Rezoning Transportation Analysis

Petition Number: #2022-125

General Location Identifier: 06507367

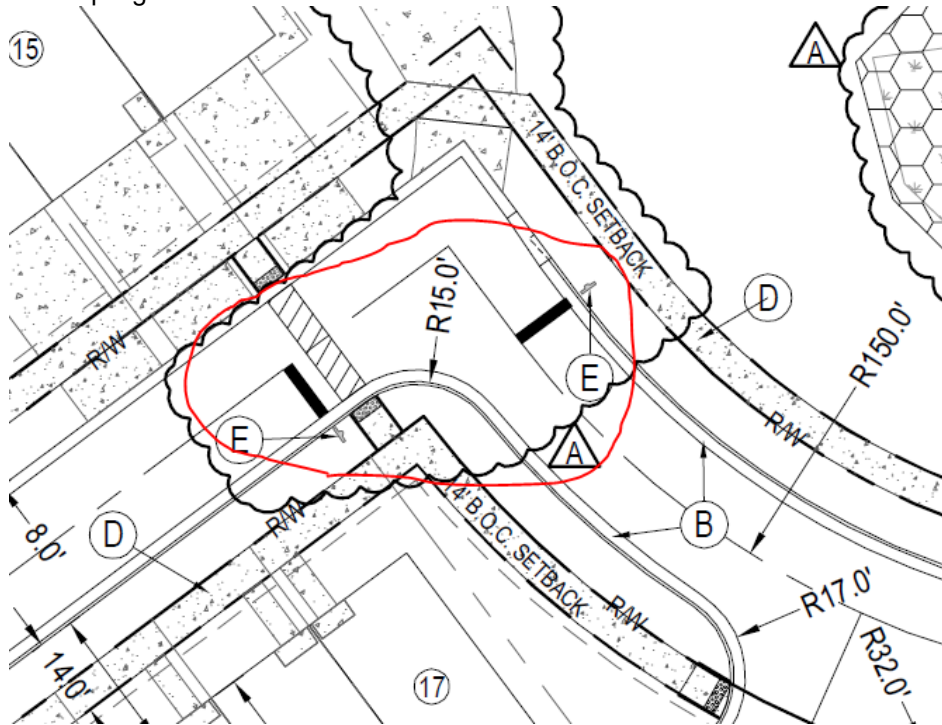
4. ~~Revise site plan and conditional note(s) to commit to construct an 8-foot planting strip, and 6-foot sidewalk on all internal public roadways per Chapter 19. The site plan shall label and dimension both items from the back of curb and gutter or edge of pavement.~~

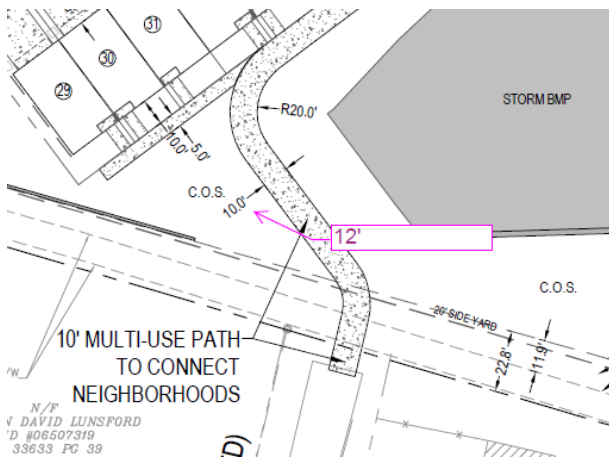
6. ~~Revise site plan and conditional note(s) to meet CDOT standards for public roadway geometry. Label each roadway as public or private.~~

Clarifying Comment 01-27-23: CDOT will not accept current design. Revise roadway to remove 90 degree turn and satisfy CDOT standards for public roadway geometry. Remove crosswalk, stop bars, and stop signs.

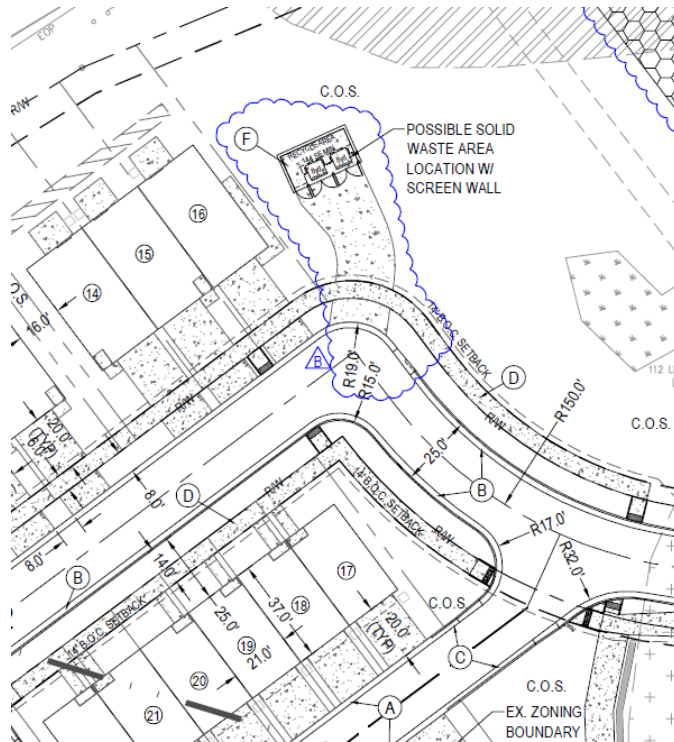
7. ~~Revise site plan and conditional notes(s) by changing the 10-foot Multi-use path to a 12-foot multi-use path.~~
